**TOWN OF ADDISON  
BUILDING REPORT**

**Facility Information:** **Facility Name:** Athletic Club  
**Facility Contact:** Lisa Pyles **Contact Phone:** 972-450-2878

**Accessology Inspector Information:**  
**Inspector:** Karen Jackson **Date:** April 25, 2017  
**Email:** Kjackson@accessology.com

**Latitude:** 32.950273 **Longitude:** -96.848428  
**Address:** 3900 Beltway Drive **City:** Addison **County:** Dallas

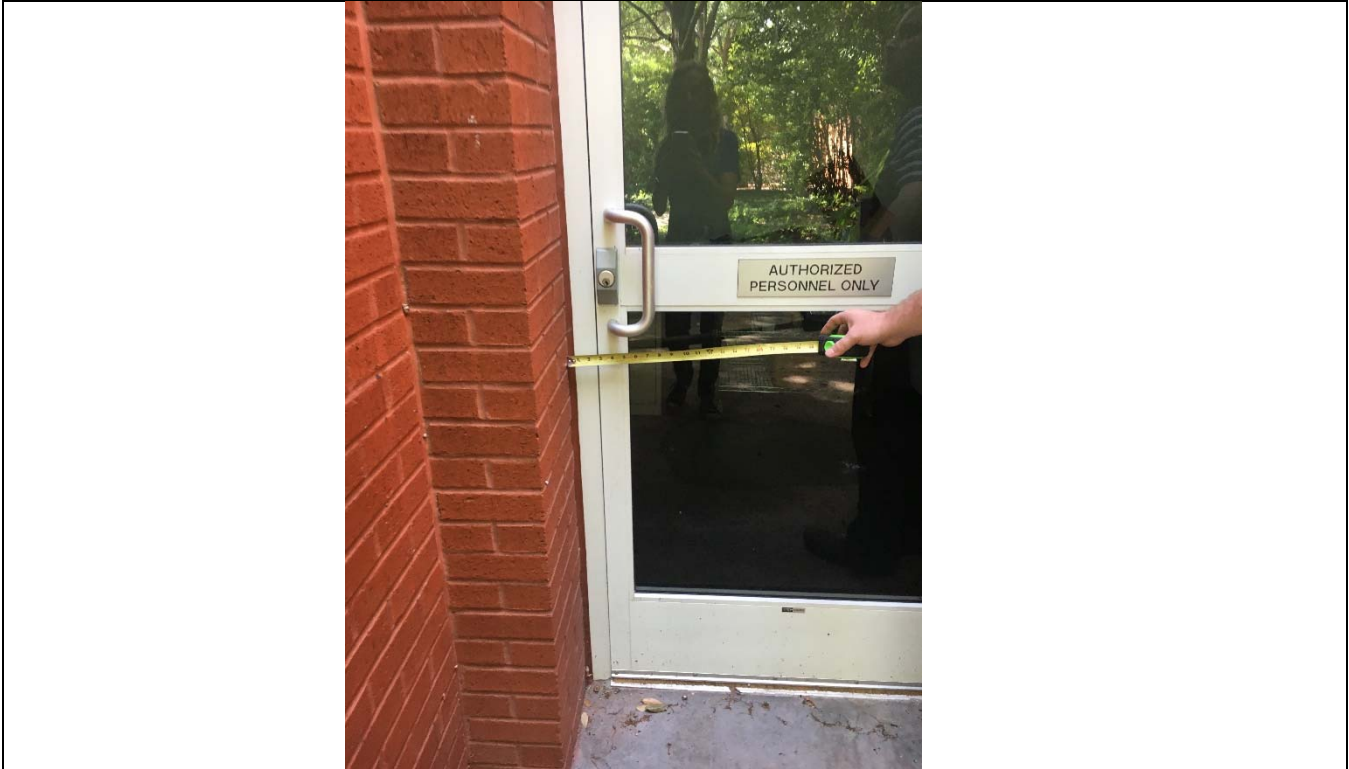
**Violation 2** - The ramp leading to the exterior upper pool area and the exterior restrooms has a 5.4% running slope with no handrails.

**Violation 3** - There is no signage provided at the outside pool area to direct people to the accessible route to the upper pool area.

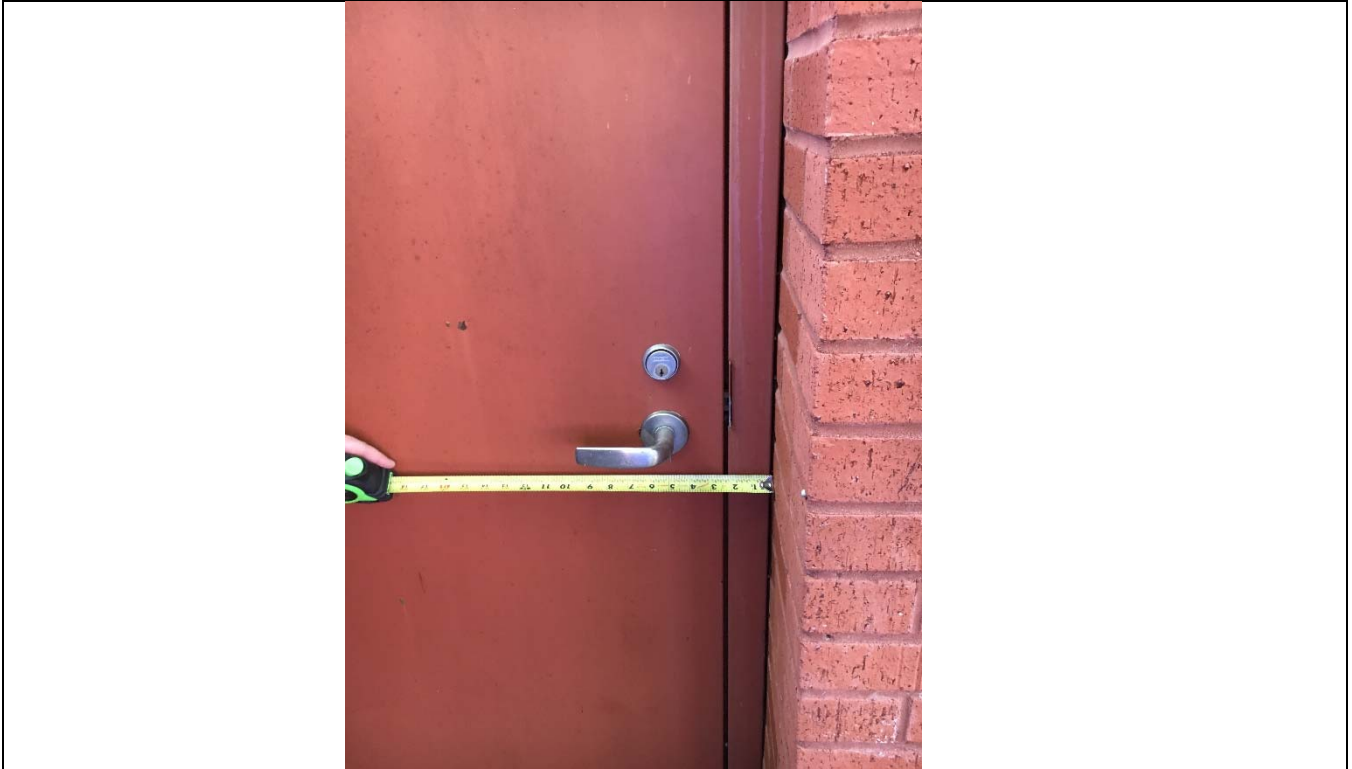
**Violation 4** - A portion of the sidewalk along the back area by the benches at the outdoor pool area has a 5.7% running slope.

**Violation 5** - The door at the employee entrance from the outside pool area does not have an 18" maneuvering clearance on the pull side.

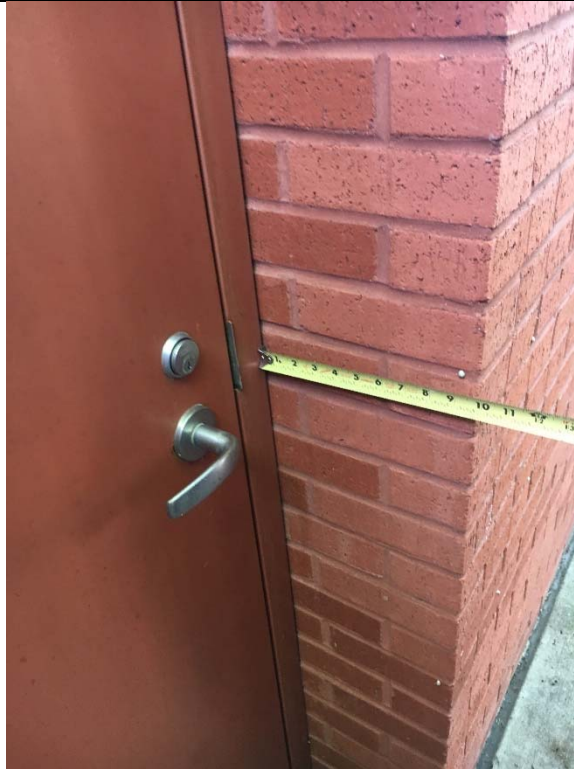
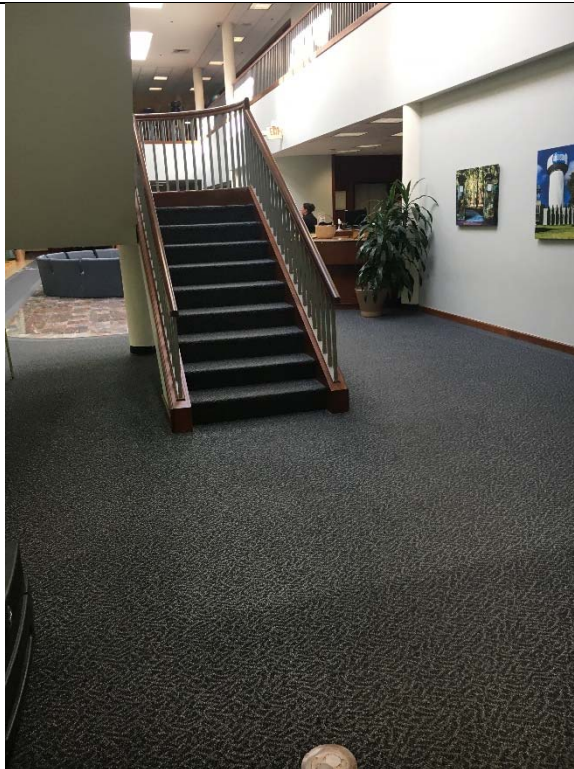
**Violation 6:** This exterior door by the pool area that leads to the interior stairs does not have the required minimum of 18" provided on the pull side.

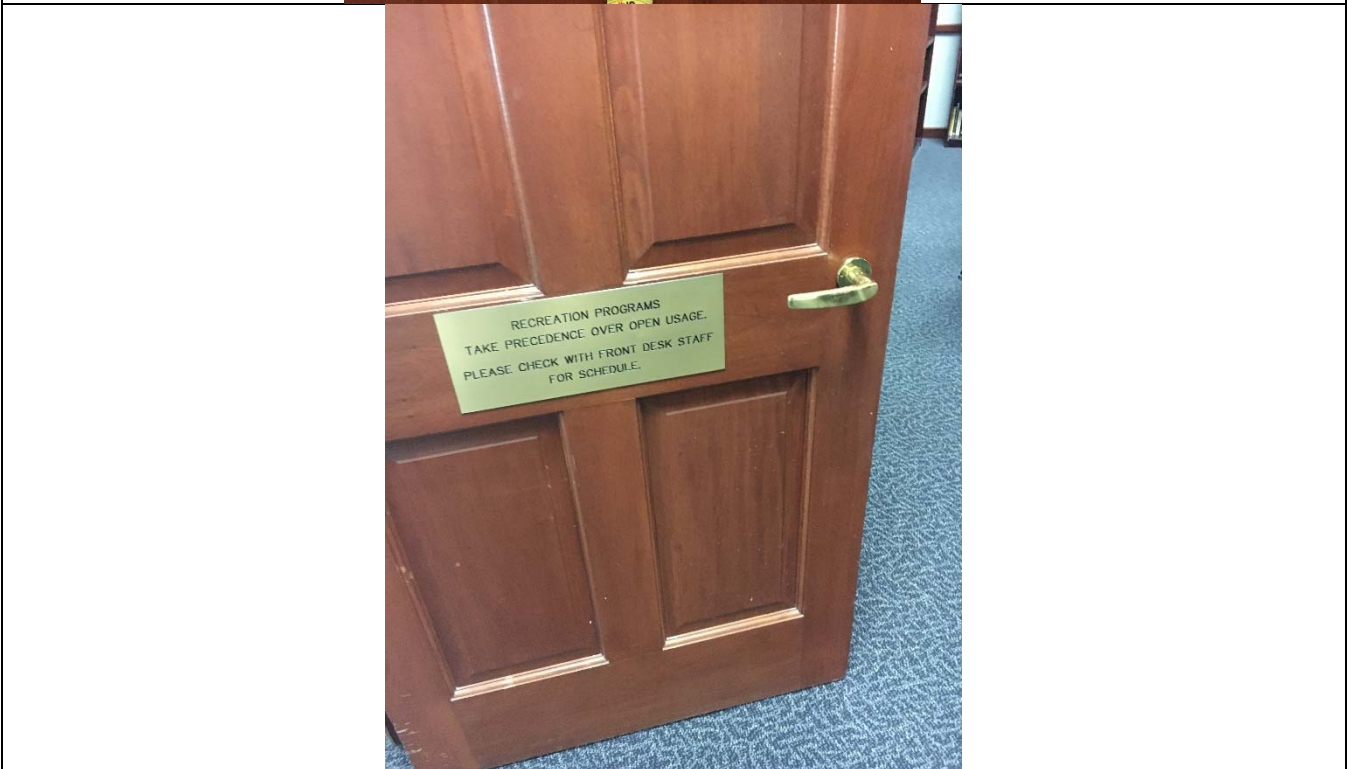
**Violation 7:** The area under the stairs to the second floor is not protected from access.

**Violation 8:** The service desk at the front entrance is at 42 3/8" and does not provide an accessible portion of counter.

**Violation 9:** Signage for the Multipurpose Room is not mounted in the correct location, it is mounted on the side wall to the right of the entrance.

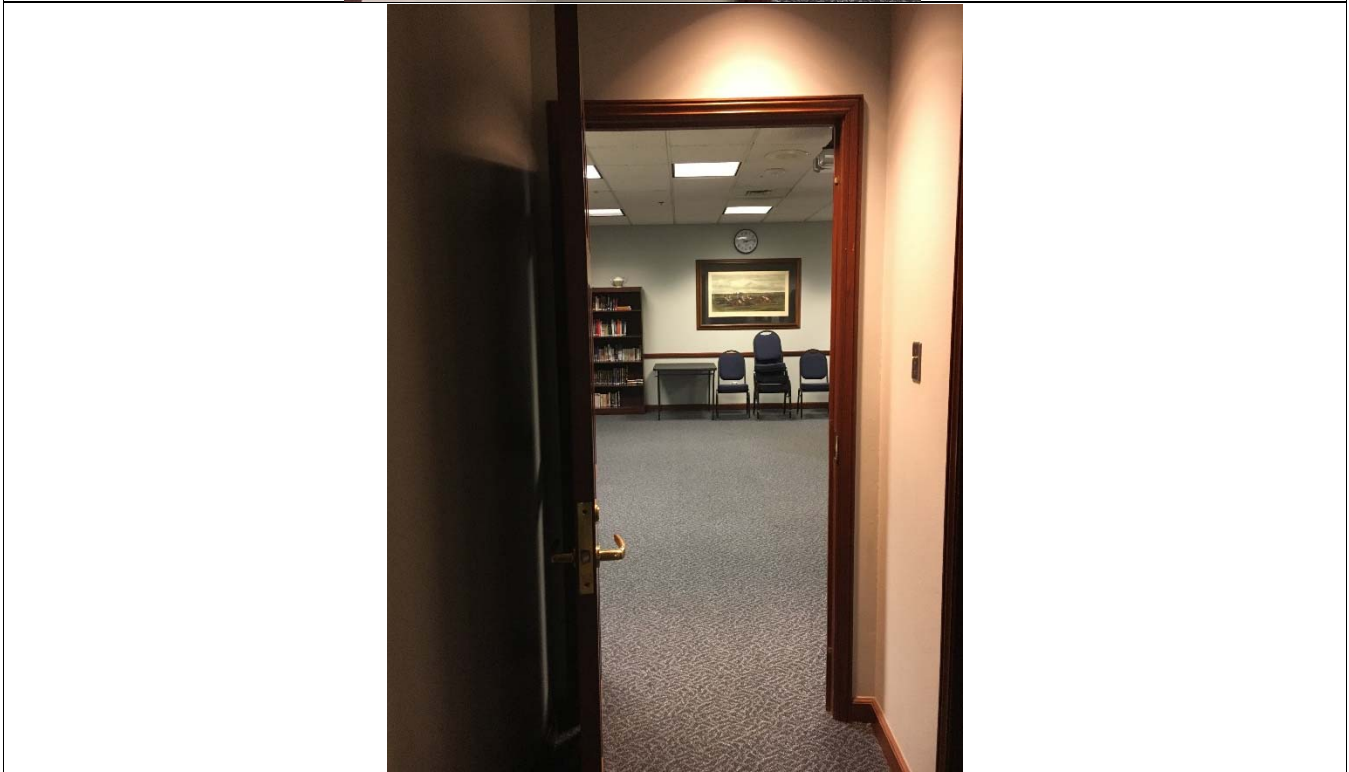
**Violation 10 -** The signage for the Gymnasium is located on the wall next to the doors.

**Violation 11** - The conference room signage is mounted on the door and has an operable sliding part that is at 65" where a maximum of 48" is required.

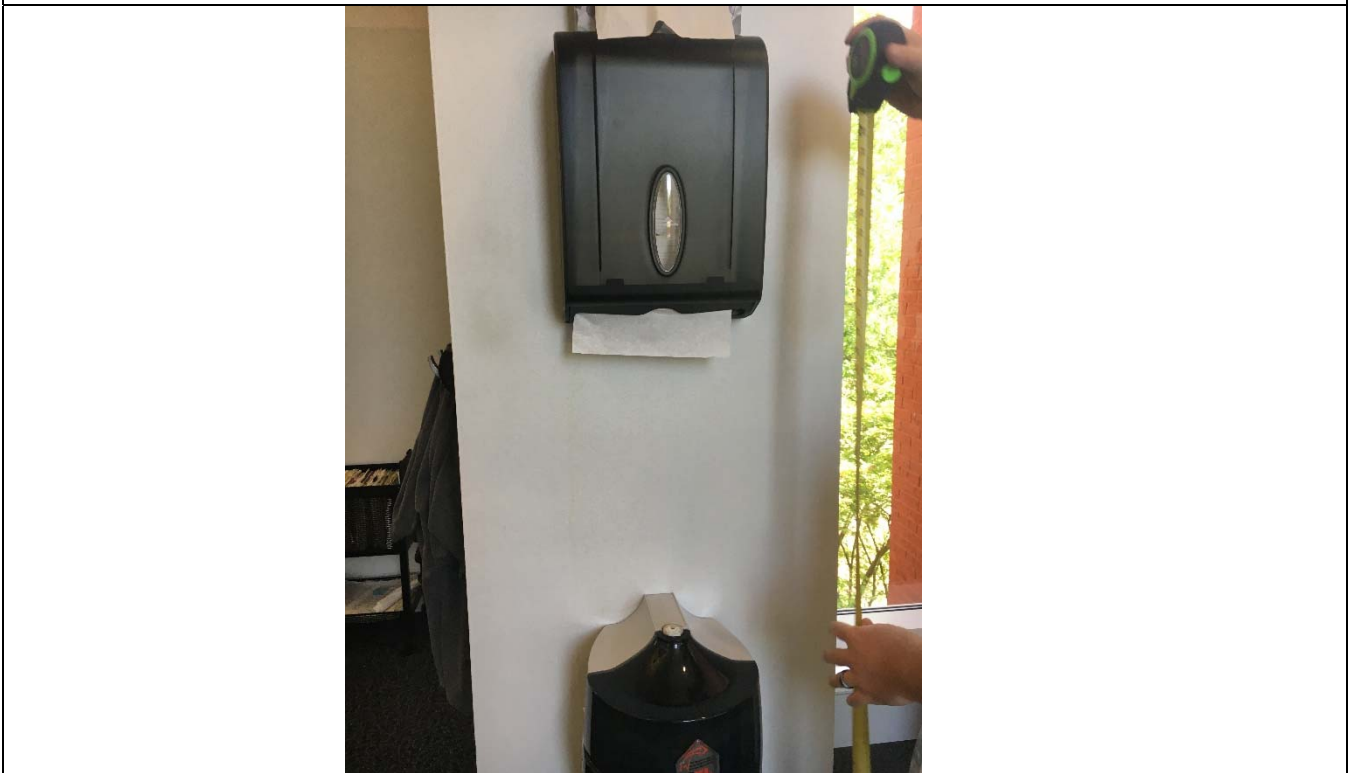
**Violation 12** - There are 2 doors into and out of the conference room and neither door has the minimum 18" required maneuvering clearance on the pull side.

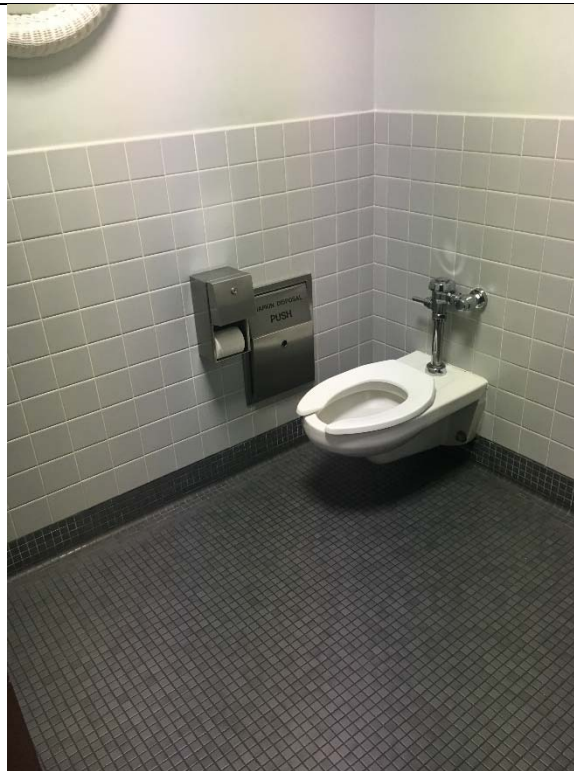
**Violation 17** - The lavatory in the child care restroom lavatory pipes are not protected.

**Violation 18** - The lavatory in the child care restroom lavatory has knob style handles requiring grasping and twisting to operate.

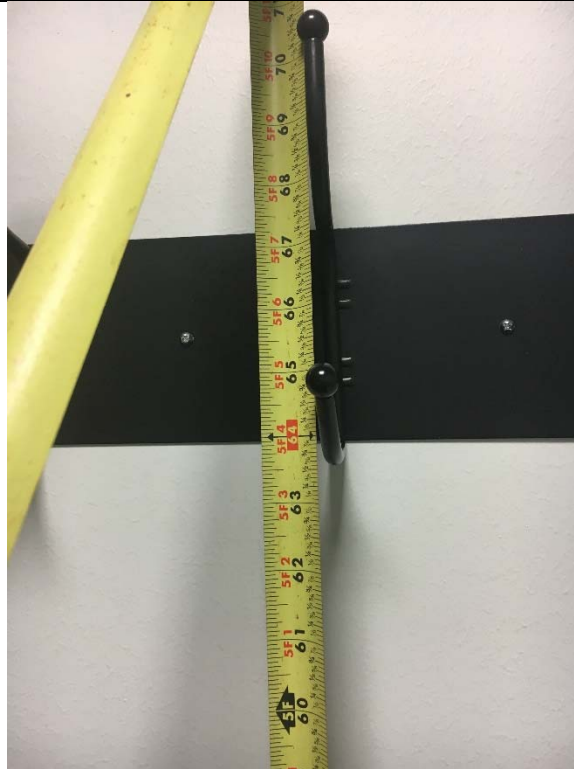
**Violation 22** - Single user restroom on 2nd floor - The lavatory encroaches into the required clear floor width of the water closet.

**Violation 23** - Single user restroom on the 2nd floor - The lavatory pipes are not wrapped.

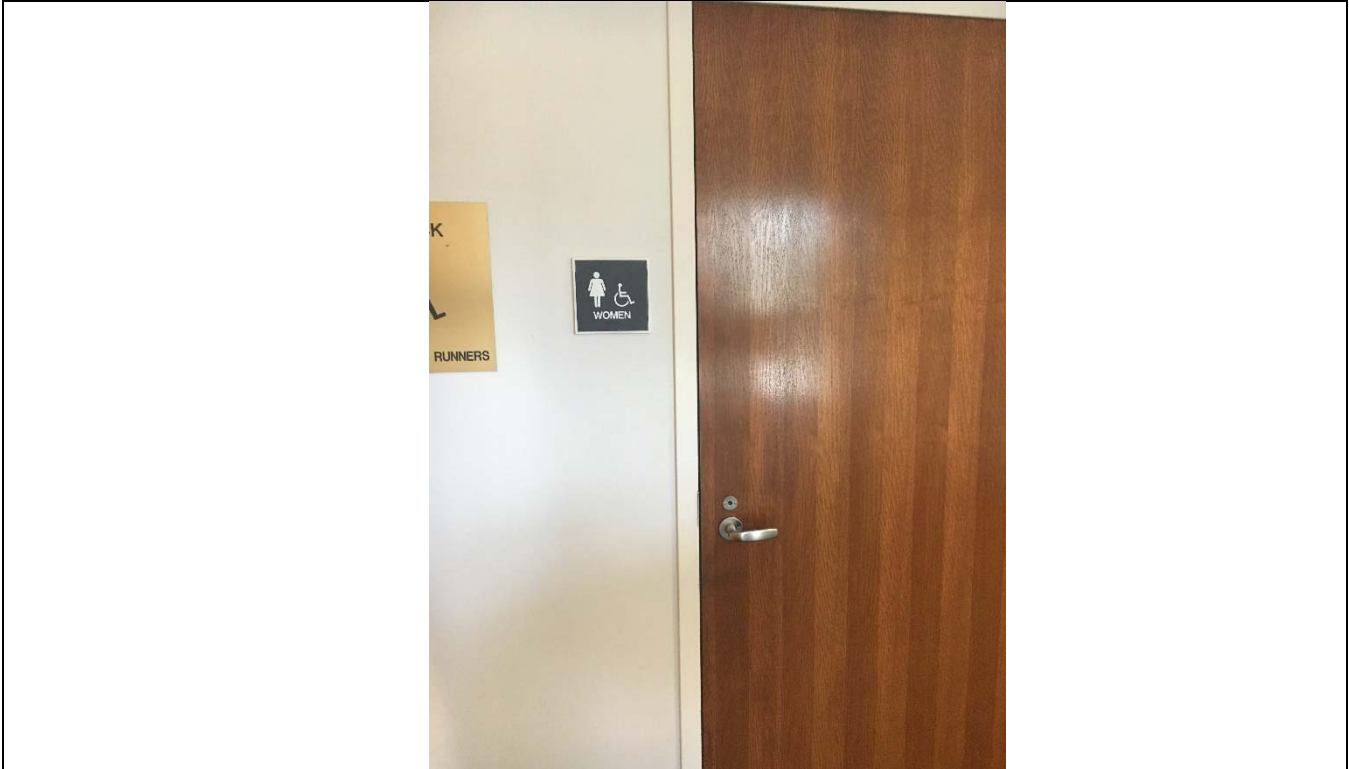
**Violation 24** - Single user restroom on the 2nd floor - The mirror is mounted with the bottom of the reflective surface at 49" where a maximum of 40" is required.

**Violation 25** - Single user restroom on 2nd floor - The paper towel dispenser's highest operable part is at 50" and the coat hook are mounted at 65".

**Violation 26** - 2nd floor Men's and Women's restrooms by the track - The lavatories encroach on the required clear floor width of the water closets.

**Violation 27** - 2nd floor Men's and Women's restrooms by track - The mirrors are mounted with the bottom of the reflective surface at 41" where a maximum of 40" is required.

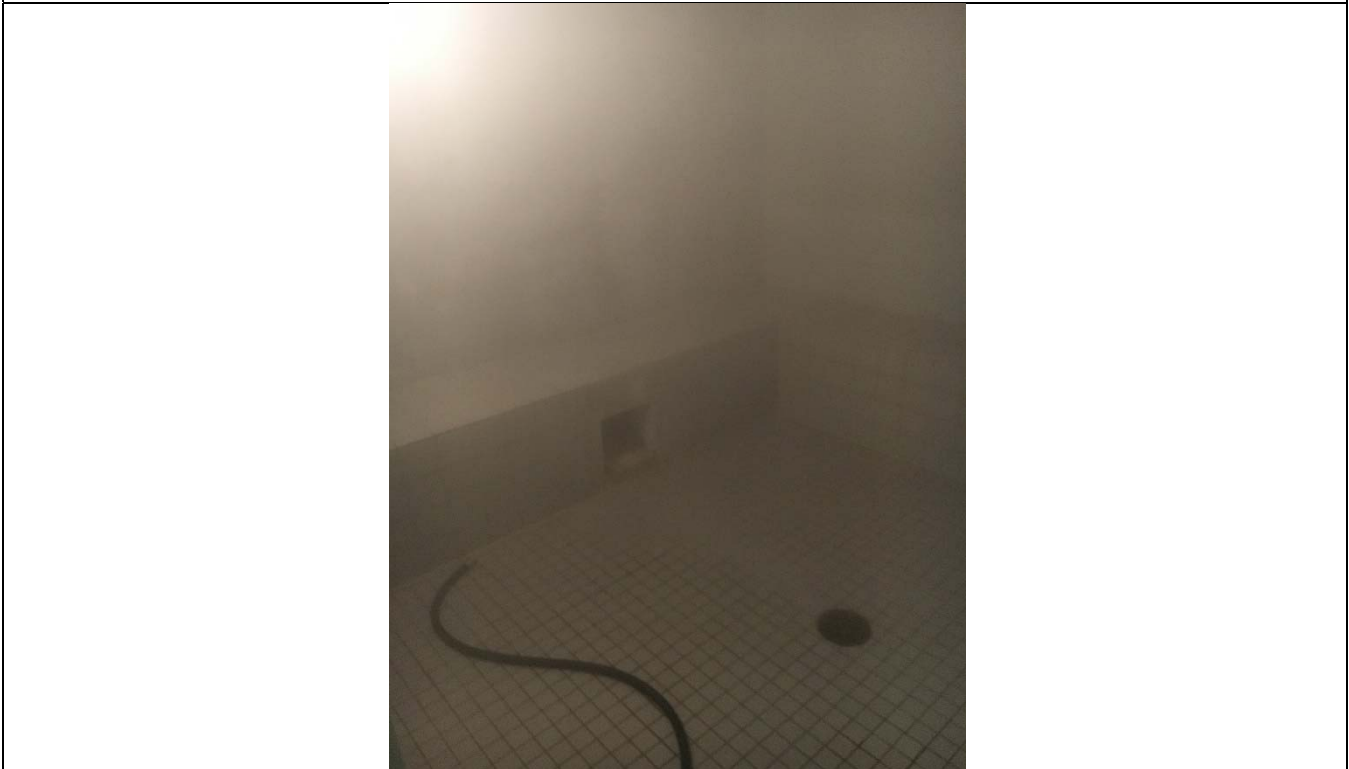
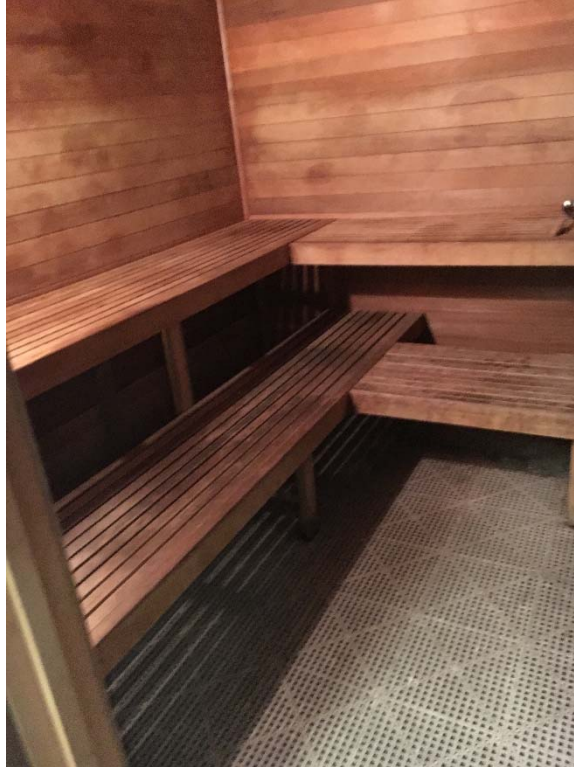
**Violation 28** - 2nd floor Men's and Women's restrooms by track - Coat hooks are mounted with the highest operable part at 63" where a maximum of 48" is required.

**Violation 29** - The doors to the 2nd floor Men's and Women's restrooms by track require more than 5lbs of pressure to operate.

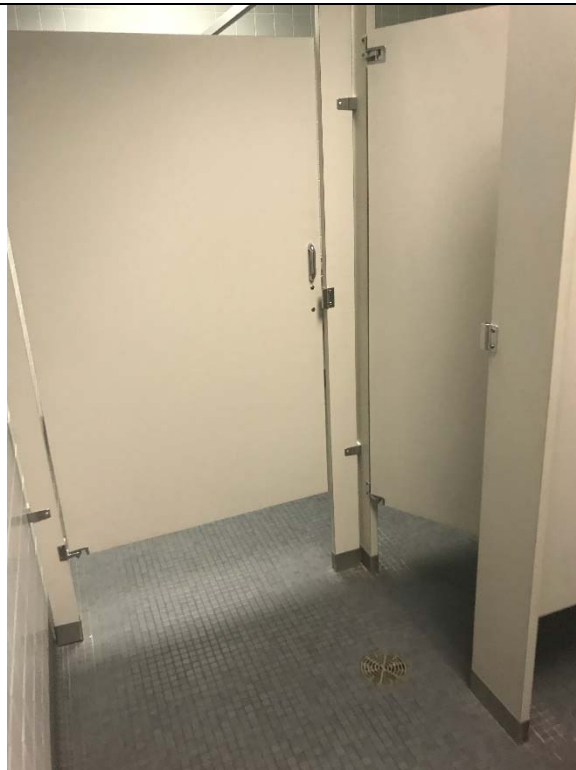
**Violation 36 - Women's Locker Room - Light switch is mounted at 54".**

**Violation 37 - Men's Locker Room - There is a 5.7% slope leading into the sauna, there is no level landing provided.**

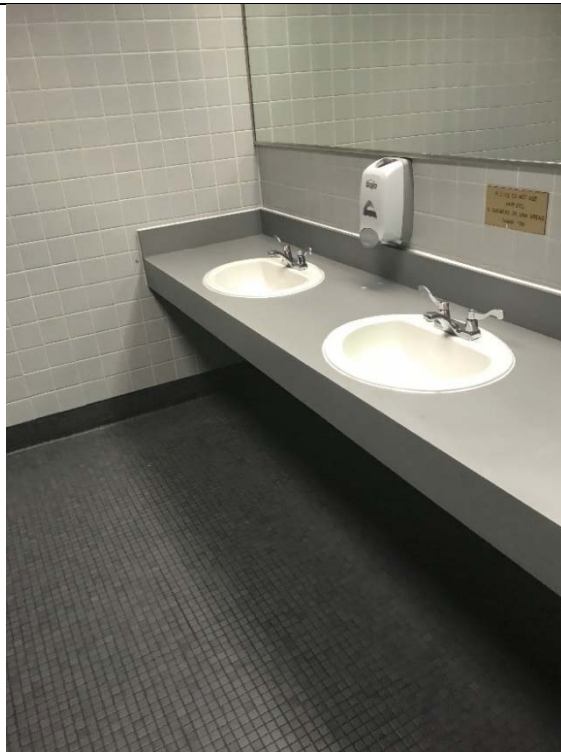
**Violation 38 - Men's Locker Room - The sauna and steam rooms do not have accessible benches provided.**

**Violation 39 - Men's Locker Room - Accessible stall door is not self-closing.**
